**City of Ramsey**  
**Agenda**  
**Special City Council**  
**Tuesday October 16, 2012**

Request for Site Plan and Conditional Use Permit Approval for Motor Fuel Sales and Car Wash for a Super America Located in the COR TWO Subdivision; Case of West Real Estate and Management Inc.

Re: Response to City Comments for Super America - Armstrong/Sunwood Site

**C2.1**

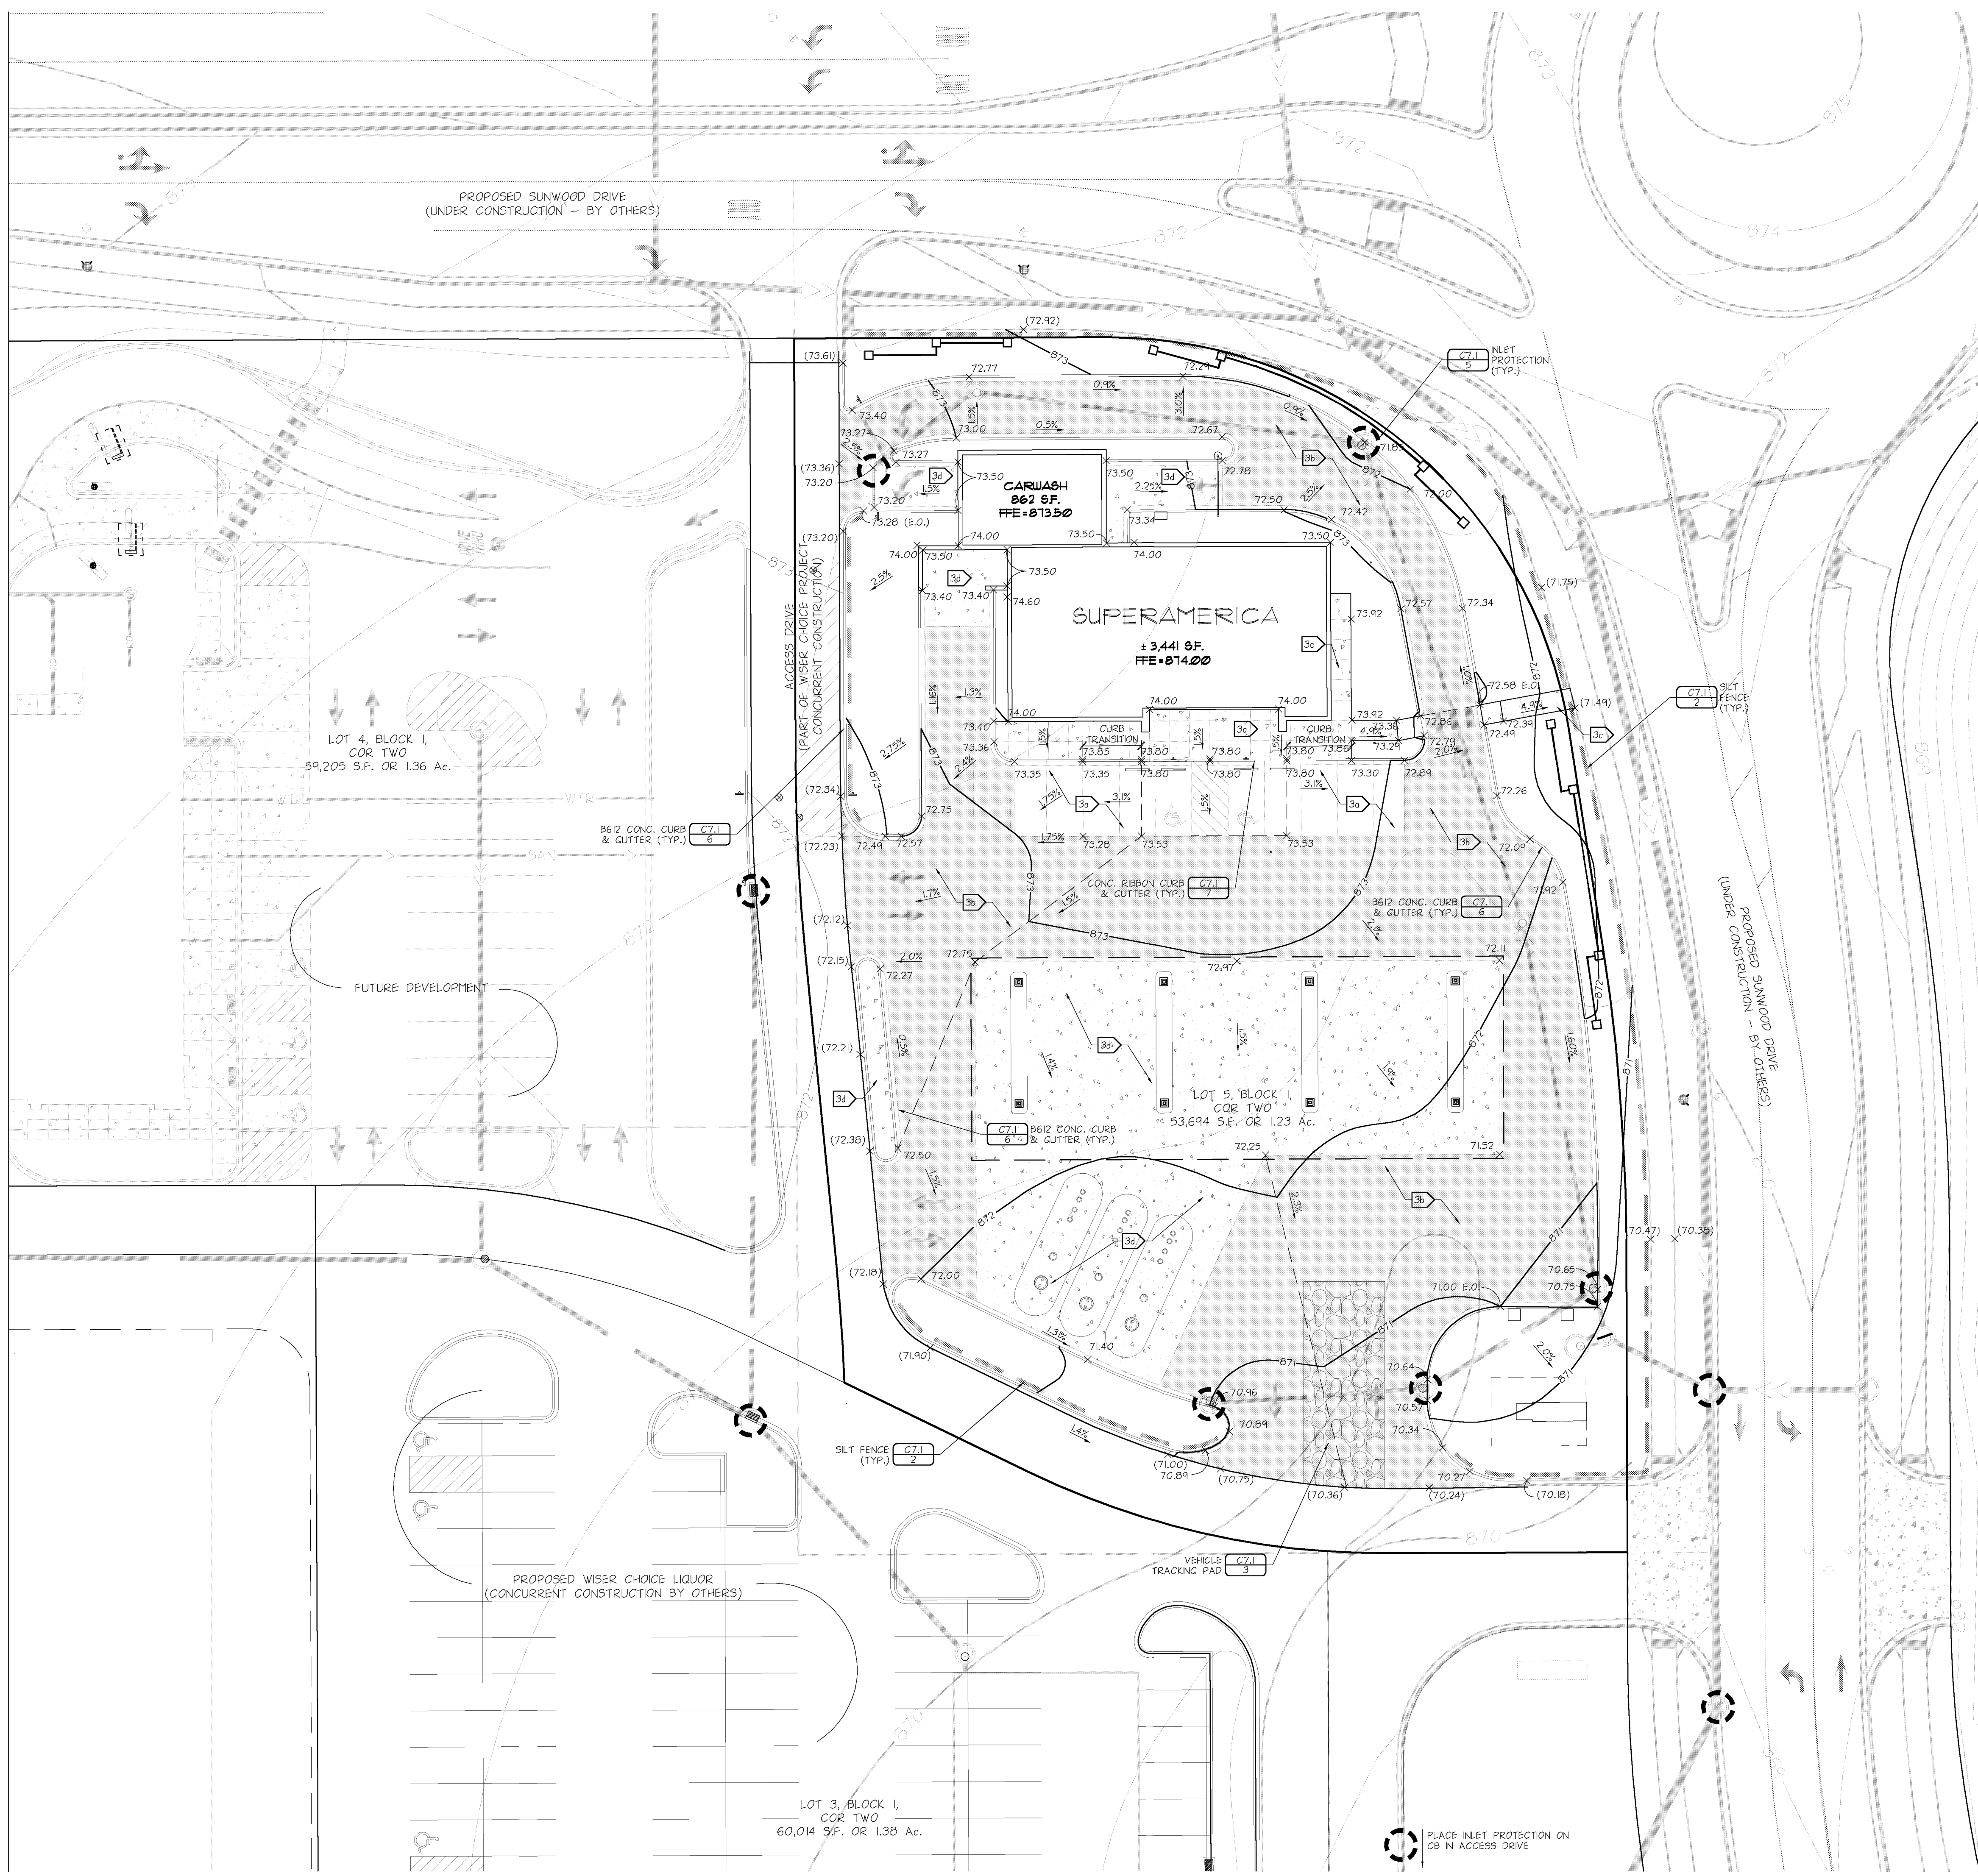
**Off-Street Parking - Spaces Required:** The COR-2 Sub-District sets a minimum parking space standard of two (2) spaces per 1,000 square feet and a maximum of four (4) spaces per 1,000 square feet for retail uses. The site plan proposes twelve (12) off-street parking spaces. It is City Staff's understanding that there may be shared parking for Lots 3-5 of Block 1. *If it is the intent to utilize shared parking, please submit a shared parking easement for review prior to the City releasing the Building Permit. Also, the parking summary on Sheet C2.1 must be updated to reflect the current project.*

- *On Sheet C2.1, the proposed monument sign appears to be located within a drainage and utility easement. The monument sign location must be modified to avoid encroachment in the drainage and utility easement.*

*The parking summary has been updated on sheet C2.1. This site will not utilize shared parking.*

1 FRONT ELEVATION  
1/4" = 1'-0"

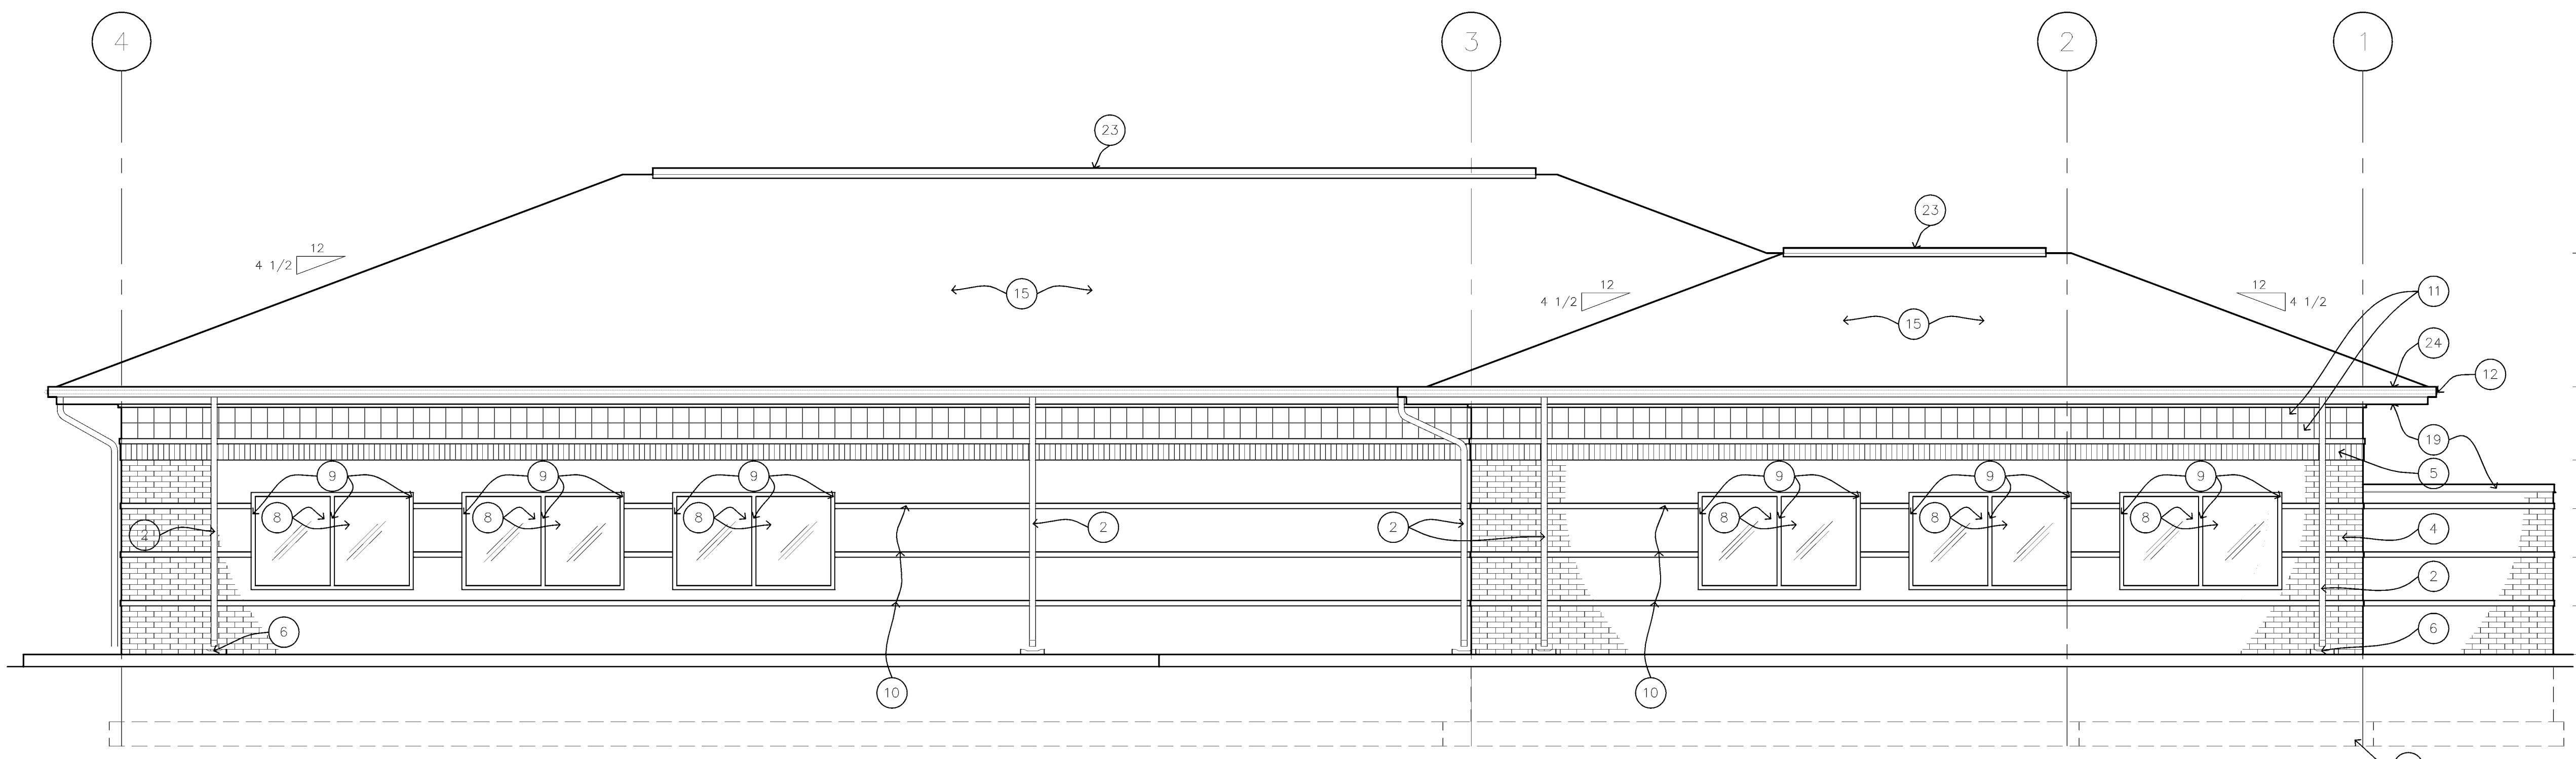
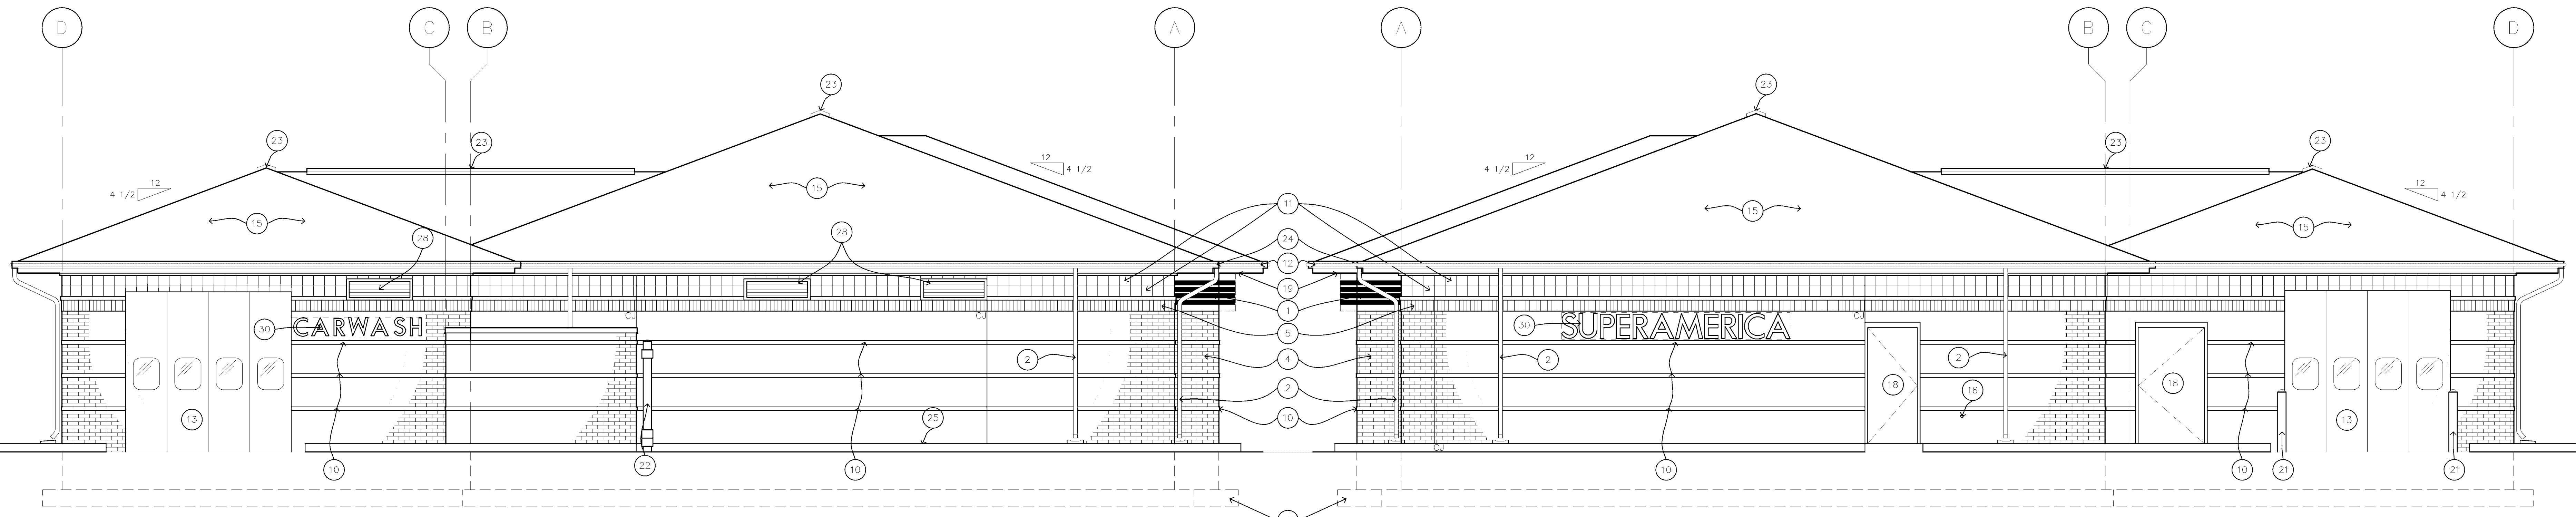
**Building Orientation:** Building orientation is subject to the Design Framework of The COR, which is incorporated by reference as part of the Zoning Code. The principal building, as well as the main entrance, should front Sunwood Dr. As proposed, it appears that the rear elevation of the building fronts Sunwood Dr with the main entrance facing the interior of the lot. *Please revise the orientation of the building and main entrance to comply with Design Framework of The COR. An alternative may be to enhance the street presence of the rear and right elevations of the building with the use of greater roof articulation and pitches, additional windows, awnings etc., to meet the intent of the Design Framework. Color renderings of each of the four (4) elevations should be submitted to provide a better conceptual image of the building from the street.*

*Applicant will provide additional 3D modeling to further demonstrate the architecture along the rear and right elevations and will study additional architectural features to further enhance the design along Sunwood Dr. New design drawings will be made available prior to the Planning meeting. A photo of an existing SA Store delineating the brick detailing will also be provided for further definition of color and texture of the wall*

*surface. In addition, consideration should be given to the context of the building in relationship to the enhanced boulevard plantings & landscape features proposed along Sunwood Dr.*
